Design Review Revisions

Child Street Open Space

Reference: Child Street Open Space – Design Revisions and Temporary Power Station
PB #179
Cambridge Crossing
Cambridge, Massachusetts

Reference: Parcel U Design Review Revision – View Glass
PB #179
Cambridge Crossing
Cambridge, Massachusetts

TEMPORARY ELECTRIC SUBSTATION & CHILD ST OPEN SPACE - DOG PARK

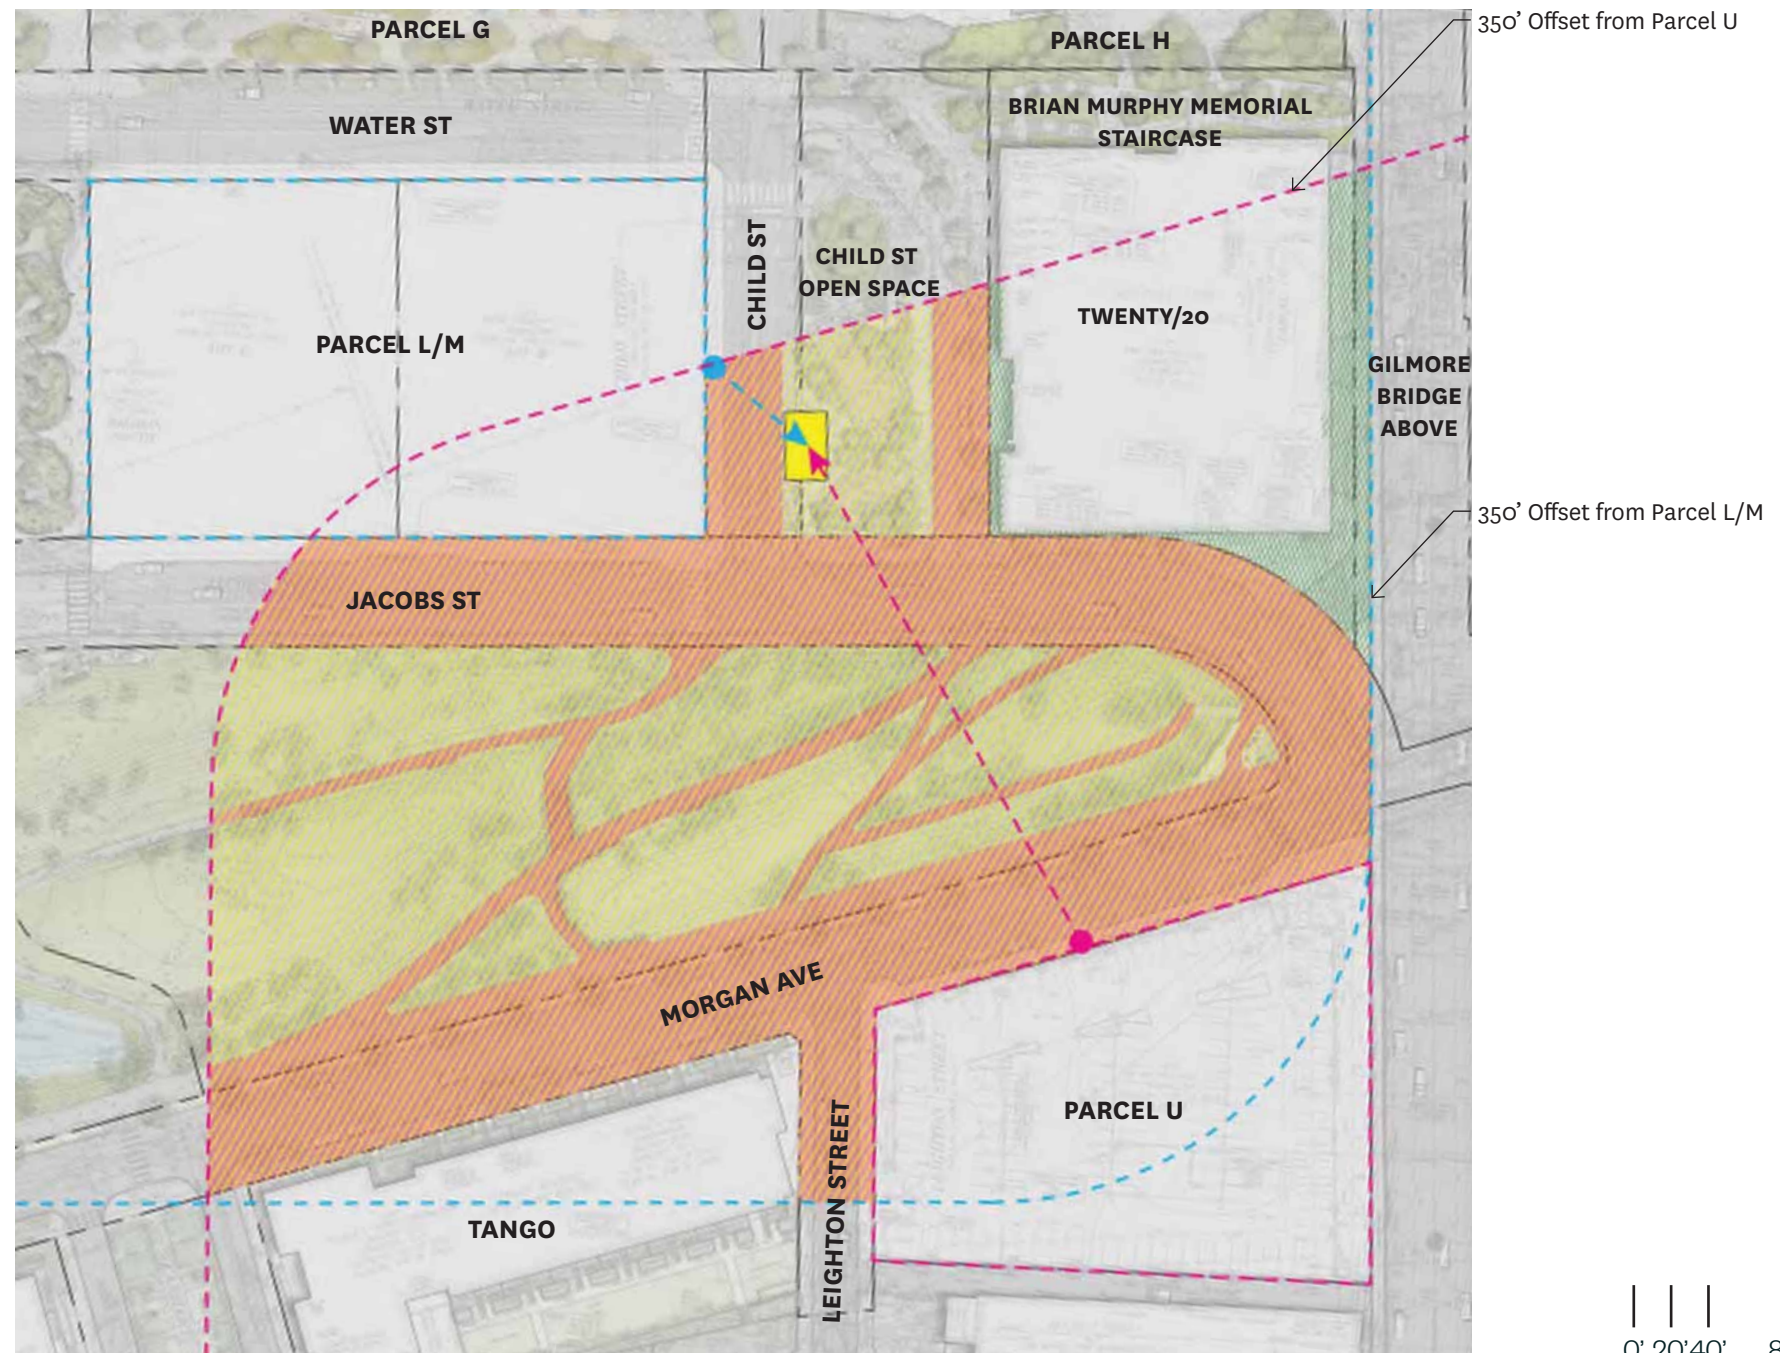
DivcoWest desires to undertake this revitalization project in connection with the development of Parcel U. The majority of the revitalization and construction of the dog park, the installation of picnic tables and the relocation of the existing bicycle racks will occur immediately. In order to be able to carry out the construction of Parcel U, and subsequently to construct Parcel LM, DivcoWest needs to utilize a small portion of the southwesterly area of Child Street Open Space for a temporary electric substation, which is depicted on the enclosed plans. The temporary substation is required because of the particular type of existing electrical service in this area of Cambridge, and because it must be located within a certain distance of the parcel under construction. (See plan entitled “Temporary Electric Substation Location”).

As indicated on the enclosed plans, the temporary power station will be surrounded by public art (mounted on chain link fence) as screening to buffer the pedestrian realm from any visual impact that would be caused by locating the temporary power station within the Child Street Open Space. Temporary construction power for Parcel U would be provided through a conduit running from Child Street Open Space under Jacobs Street, CX Common and Morgan Avenue to Parcel U along the route depicted on the plan entitled "Temporary Electric Substation Route at the Common."

- DW Property within 350' duct run from Parcel U and Parcel L/M.
- Avoid street/pedestrian path.
- Enough space to fit 22' X 36'
- Minimal impact to Public Realm and Residents.
- Minimal tree impact.
- Cannot be located on top of a below grade structure or utility.
- Flat Station pads required.
- Cannot be placed under the Bridge per Eversource standard.

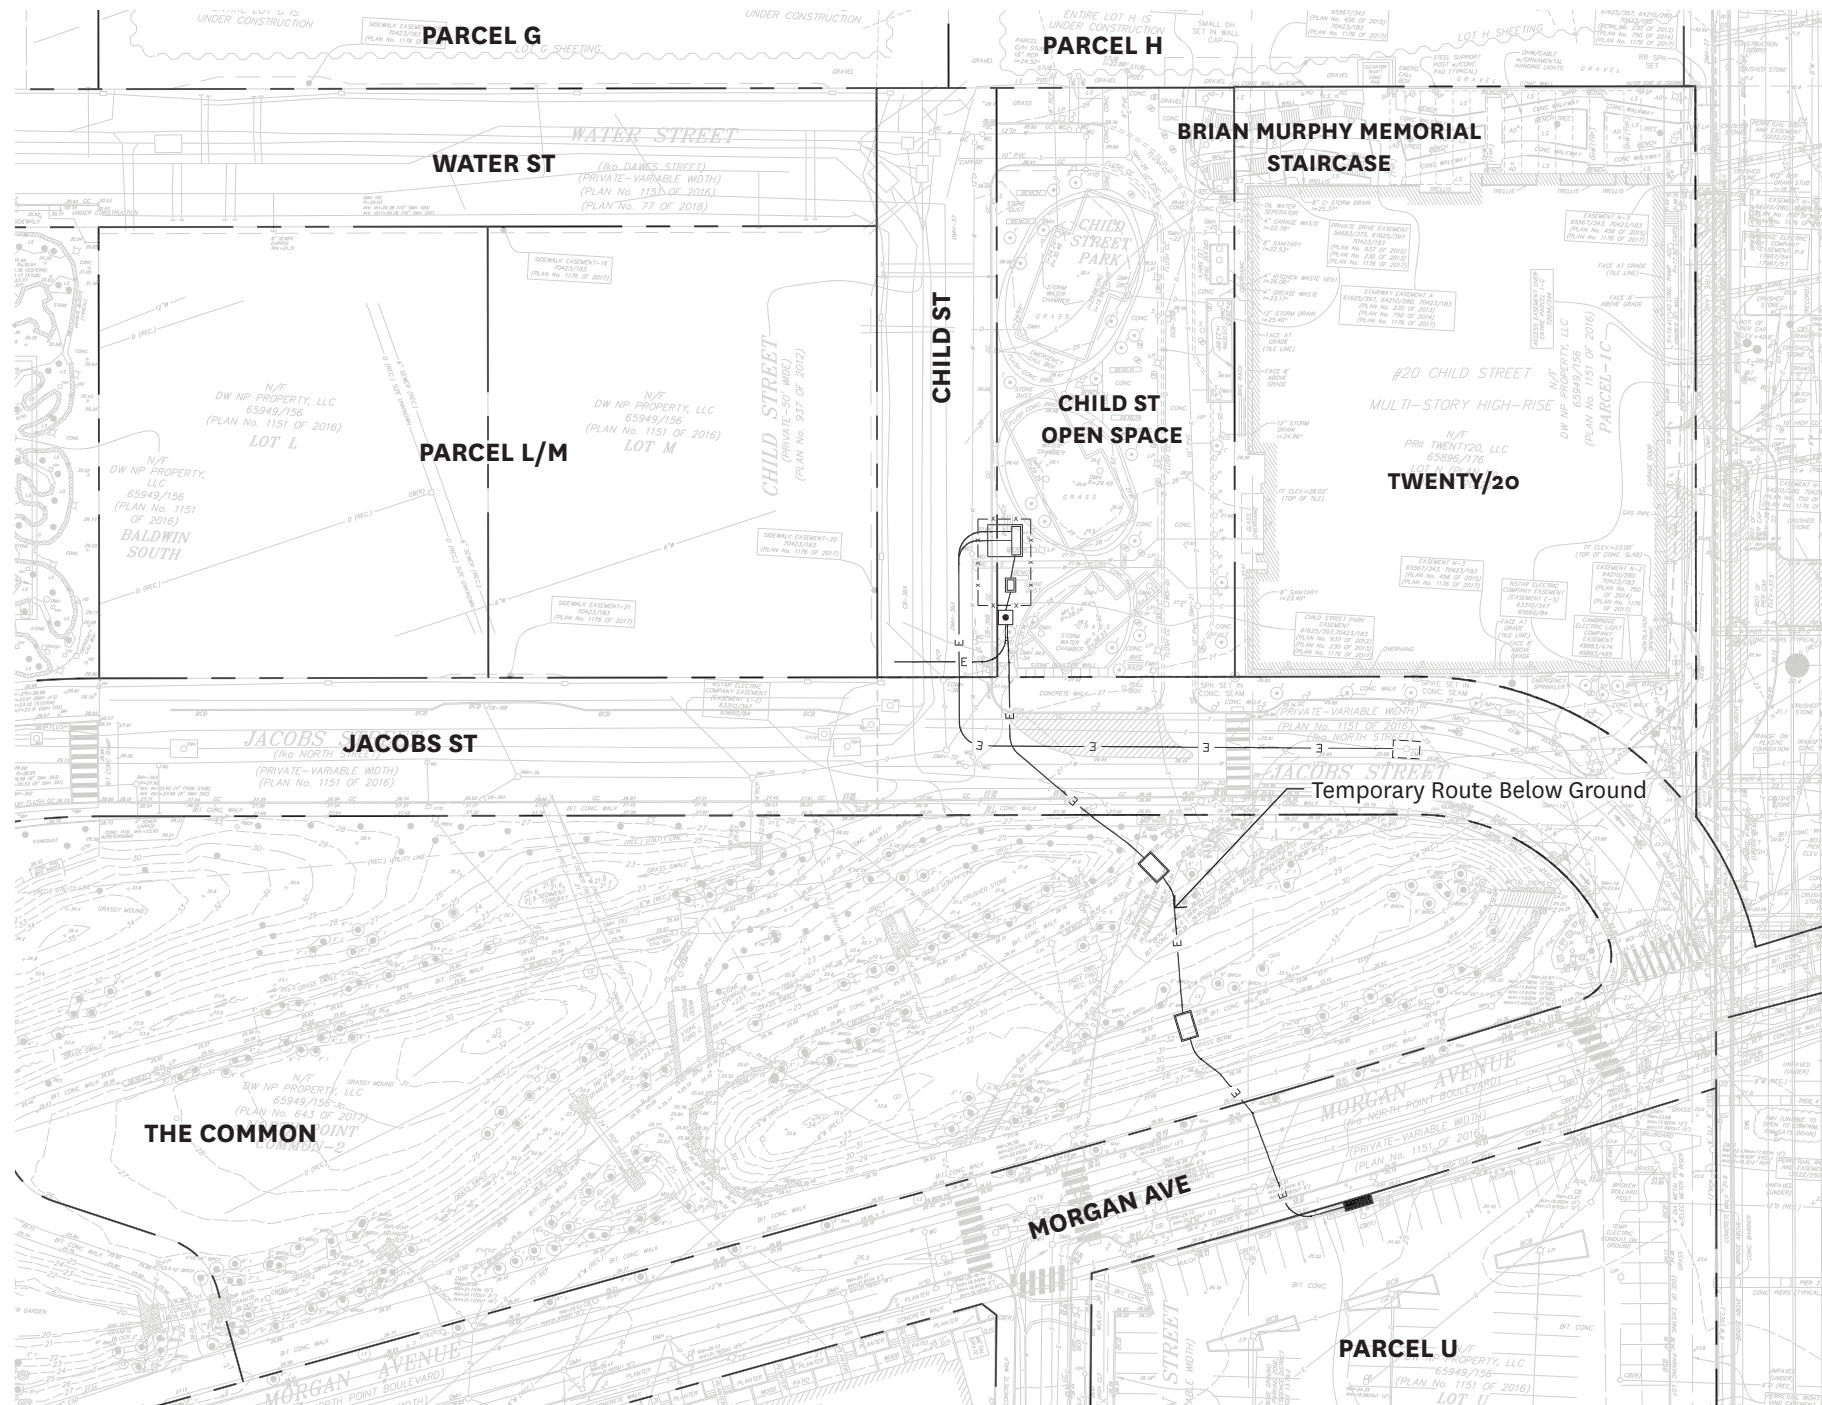
As indicated on the enclosed plans, this revitalization work will replace six (6) dead trees with new trees. Additionally, the plan will include the removal of three (3) additional trees to allow for the construction of the new dog parks and amenities. These nine (9) trees will be replaced by twenty-two (22) trees. The replacement trees will have diameters at breast height that are greater than those of the trees removed. The number of trees having a 4" DBH will double (from 6 to 12) and a 6" DBH more than tripling (from 3 to 10) upon final completion, which will increase the overall DBH within the Child Street Open Space by 70.5".

We note that the dead trees that exist today in the Child Street Open Space were planted in small tree pits with impermeable paving surrounding them. The proposed replacement trees will be planted in larger plant beds with additional structural soil under newly paved areas, to provide for a greater tree vitality. In addition, DivcoWest will investigate soil conditions after demolition of existing paving to determine if there are any other factors adversely affecting the health of these existing trees and anything that can be done to improve the vitality of the replacements. We also note that the larger replacement trees and their larger root balls have been located to avoid conflicts between the larger root balls and the existing underground cisterns.

Following permanent power activation, DivcoWest will complete the installation of the dog park for small dogs as depicted on the plan entitled "Child St Open Space – Proposed Final Condition".

Ductbank Typical Section at the Common

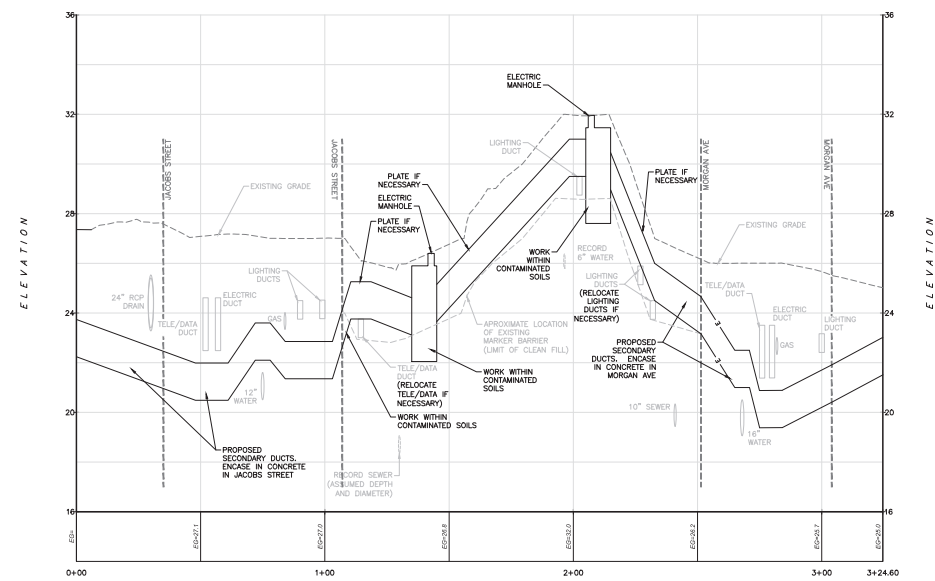
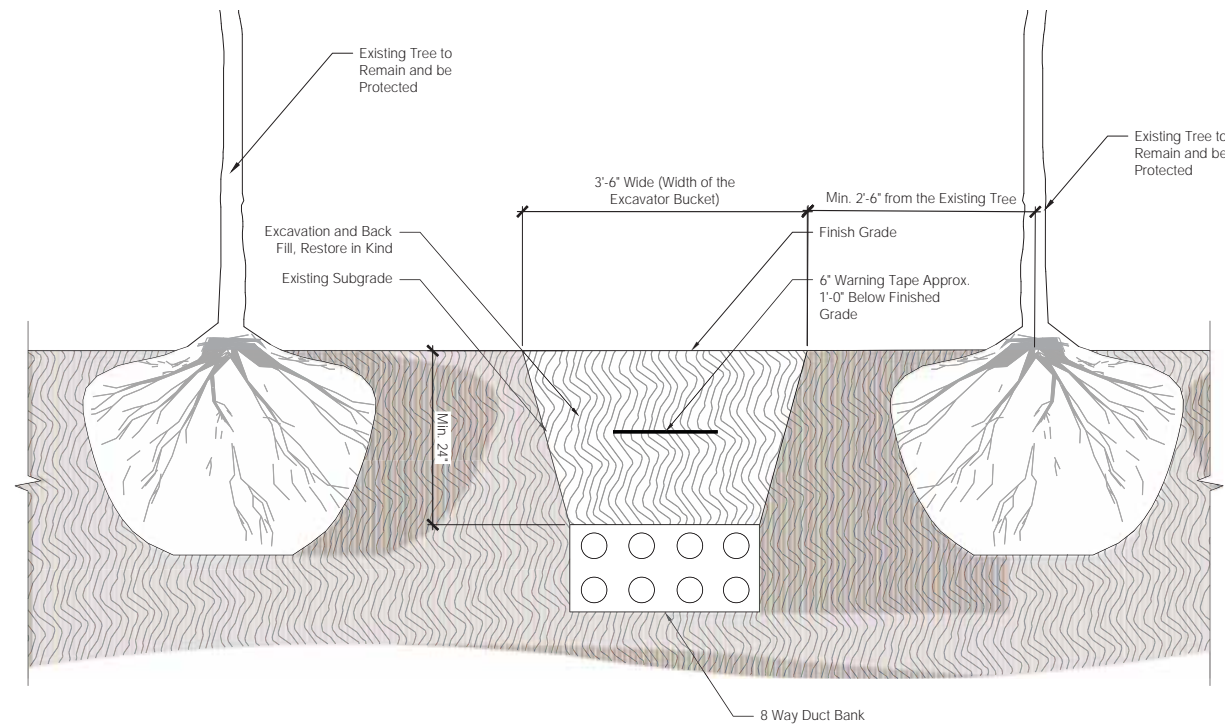
DivcoWest recommends the proposed route across the Common to minimize disruption to the residents of CX and the public. The streets and bicycle lanes at the intersection of Jacobs Street and Morgan Avenue are full of underground utilities and routing the temporary conduit through this intersection would be difficult and time consuming. By contrast, the path through the Common could be constructed quickly, and without harming any trees. The enclosed plan shows the proposed location of the temporary conduit, avoiding all trees in the Common.

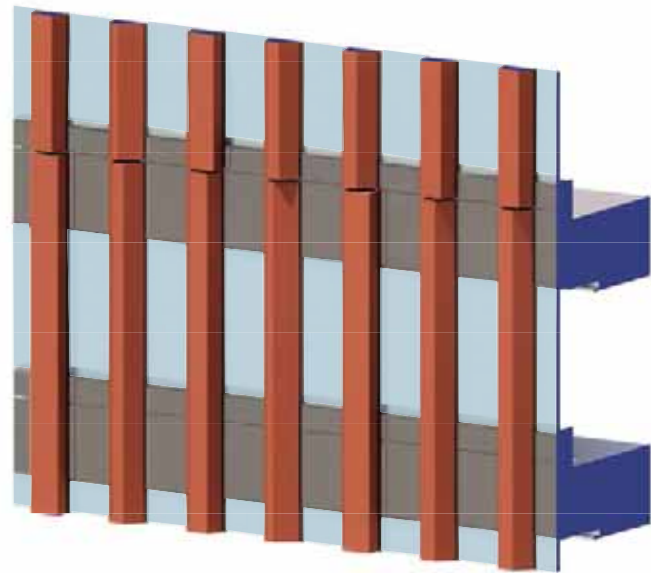
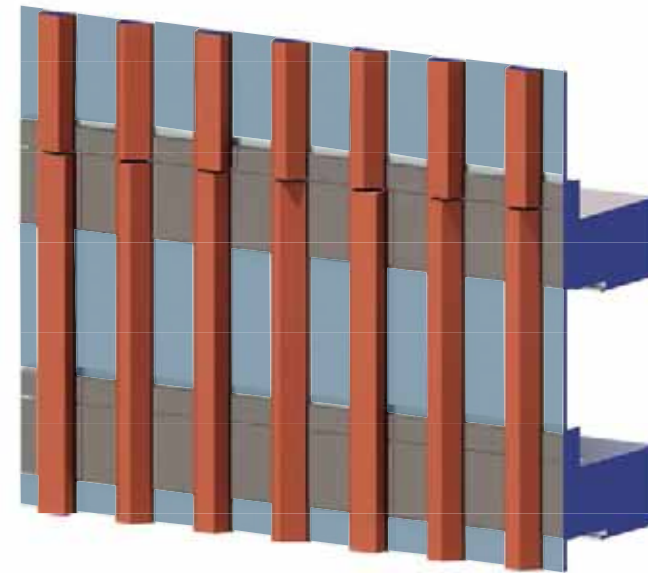
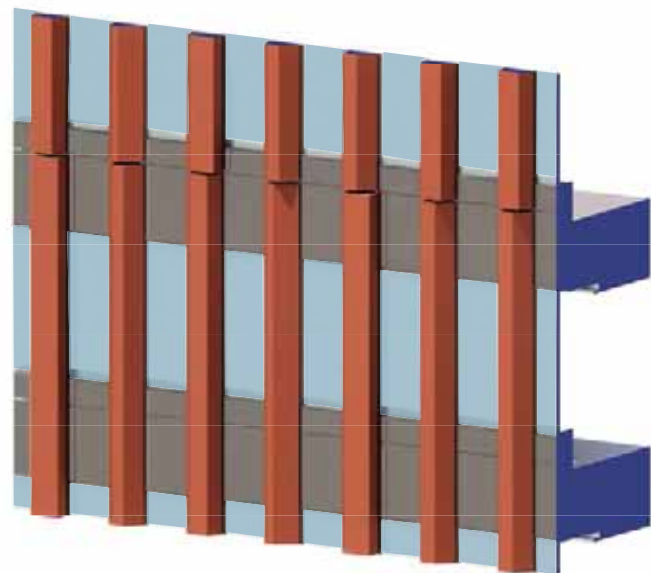
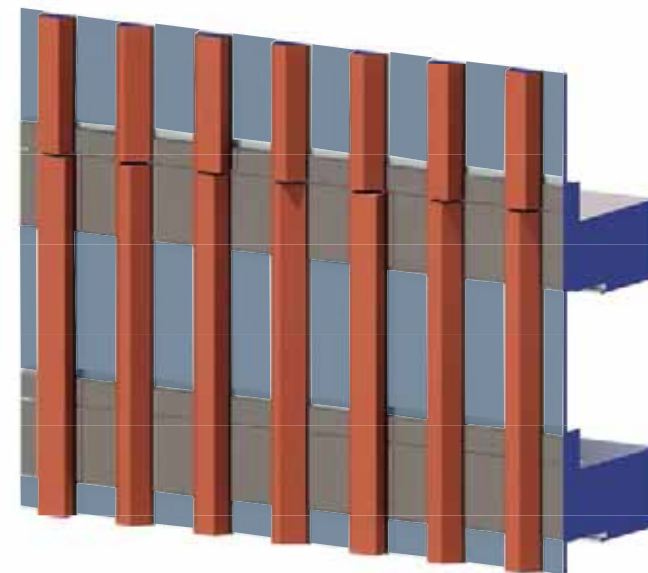
DivcoWest wishes to customize the View Glass installation at Parcel U to address two concerns that we discussed with City staff: namely, maintaining the most transparency into the building while reducing light trespass to residential neighbors to the southeast and southwest. Within a pre-established range of light transmittance and glass reflectivity, DivcoWest can modify the View Glass settings for any of the four tint states. We propose setting the four tint states as follows:

Tint State 1 – Highest visible light transmittance and least reflectivity available. This tint state is very similar to the glass that the Planning Board already approved for Parcel U.

Tint State 2 – Mid-Point between States 1 and 3

Tint State 3 – Reduced visible light transmittance and increased reflectivity, very similar to those of another project that the Planning Board approved that we discussed with City staff. Allowing this reduction would mean that shades would remain up and the windows unblocked, even on sunny days.

Tint State 4 – Least visible light transmission and highest reflectivity available. Windows would be programmed to enter this state every night between 10 pm and 7 am to further reduce light trespass from Parcel U to neighboring residential buildings to the southwest and southeast. This tint state would not be used from 7 am to 10 pm.

PROPOSED VIEW GLASS VALUES RESPONSE TO STAFF COMMENTS		
TINT STATE 1	52%	12%
TINT STATE 2	43%	10%
TINT STATE 3	35%	10%
TINT STATE 4	1%	6%
